## MEMORANDUM

**SUBJECT:** Value Engineering Submittal  
**Contract ID:** 060519-801  
**Job No.** J8P0609  
**Route.** 65  
**County:** Greene

This value engineering plan involves using the existing full depth asphalt shoulders on Route 65 in place and overlaying for the acceleration and deceleration lanes at four major side road connections on the project.

TYPICAL  
SECTIONS  
ALT. A

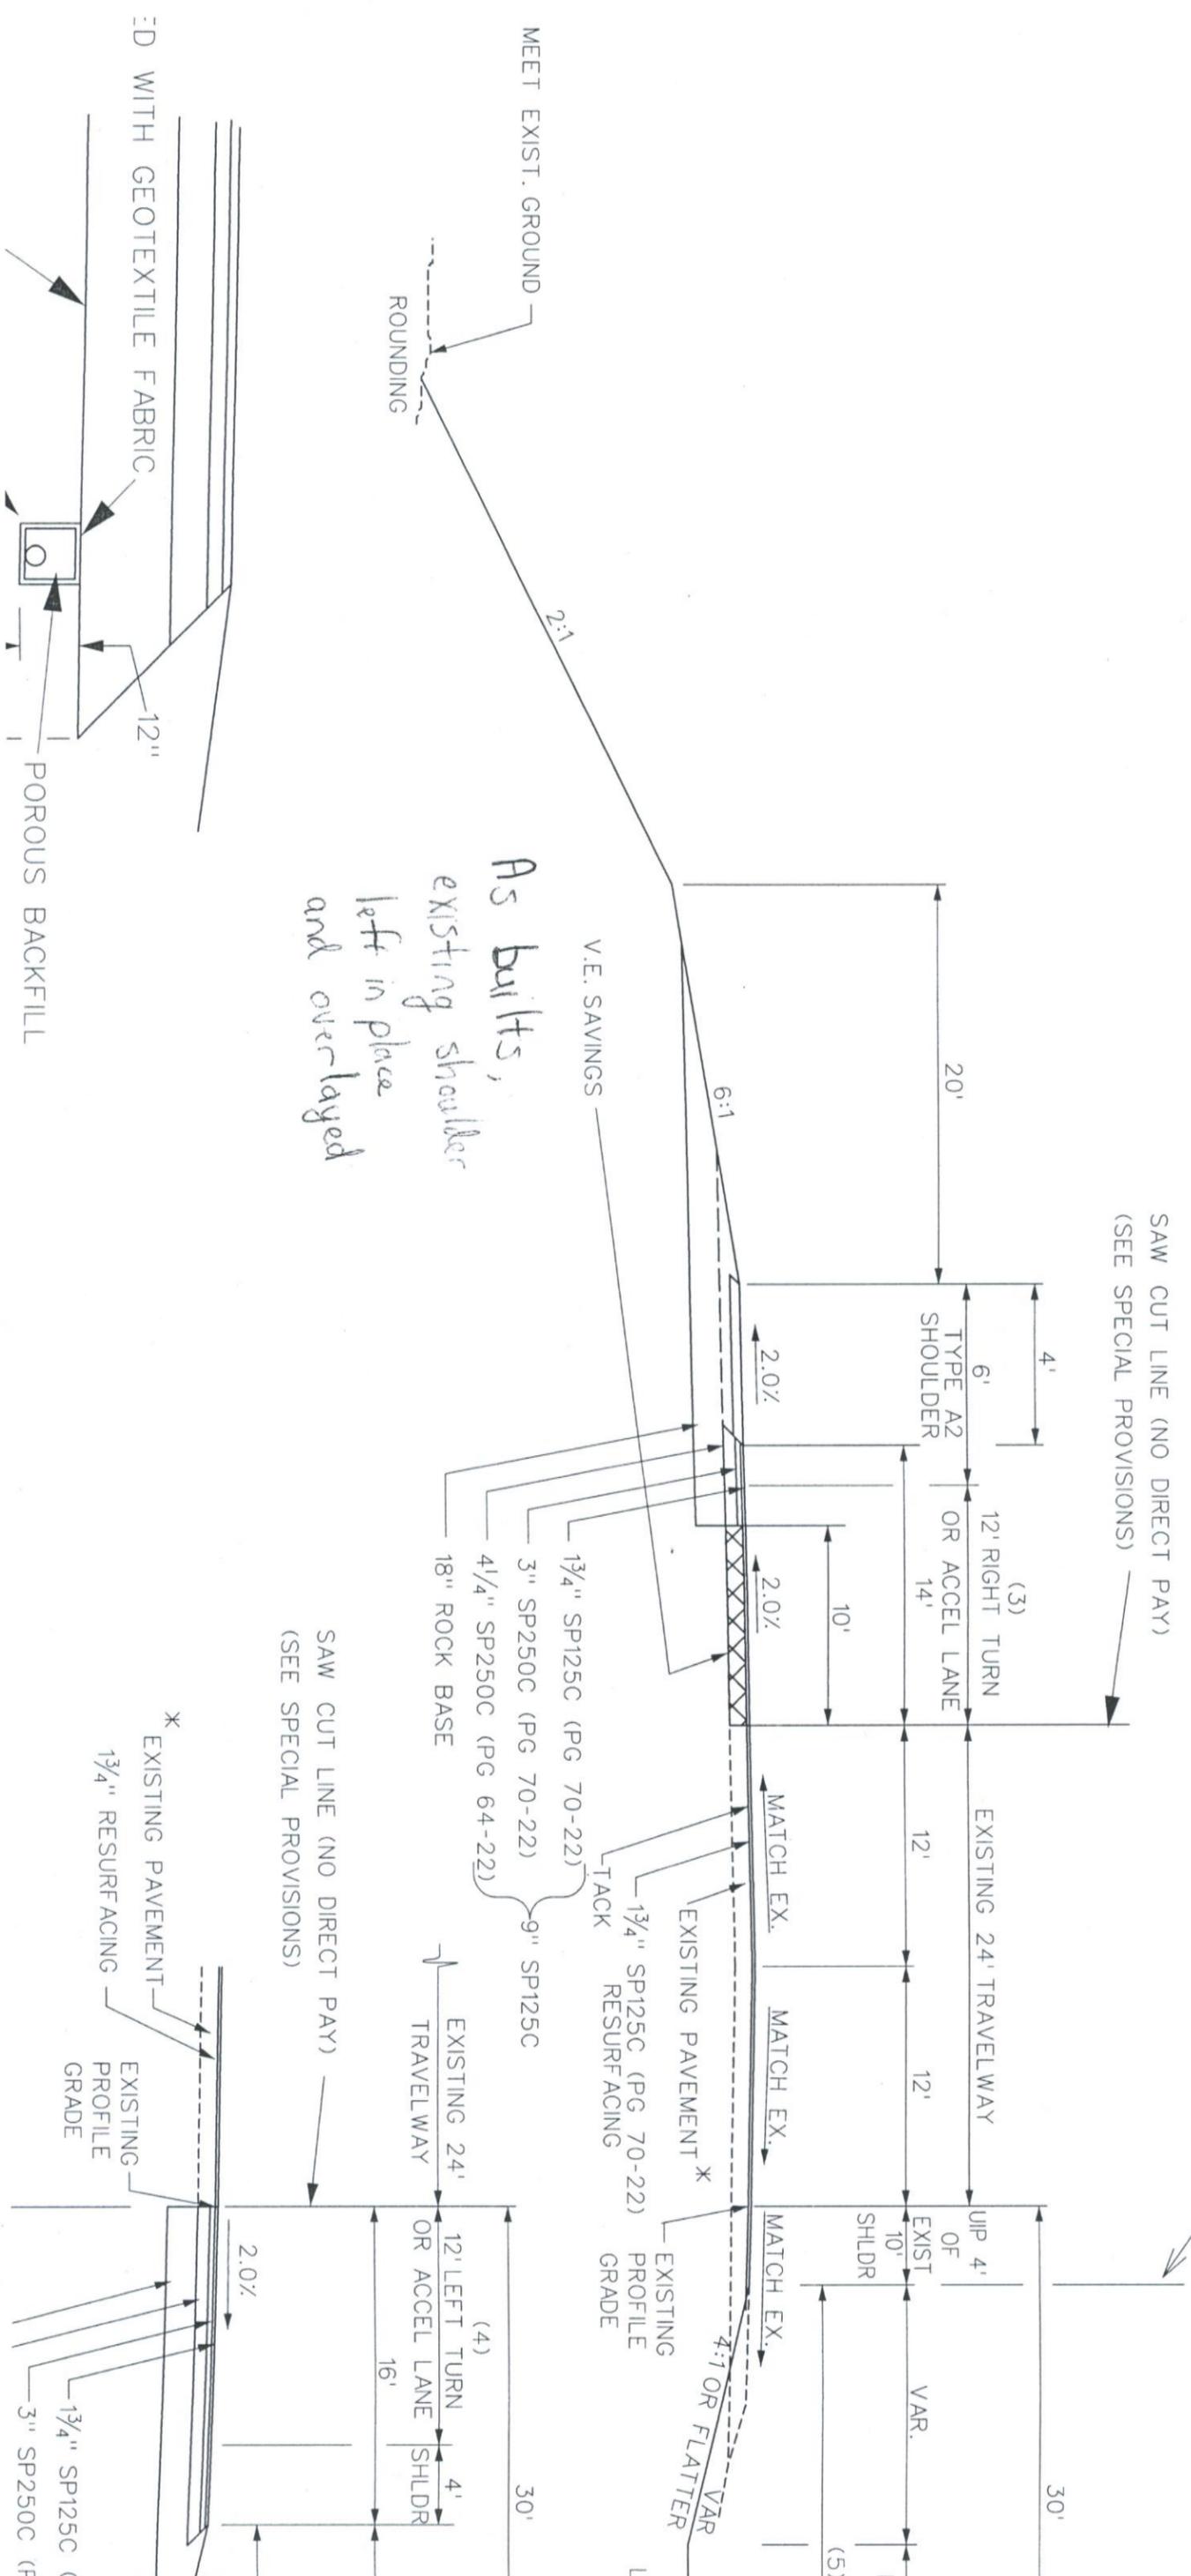
*As built,  
existing shoulder  
left in place  
and overlaid*
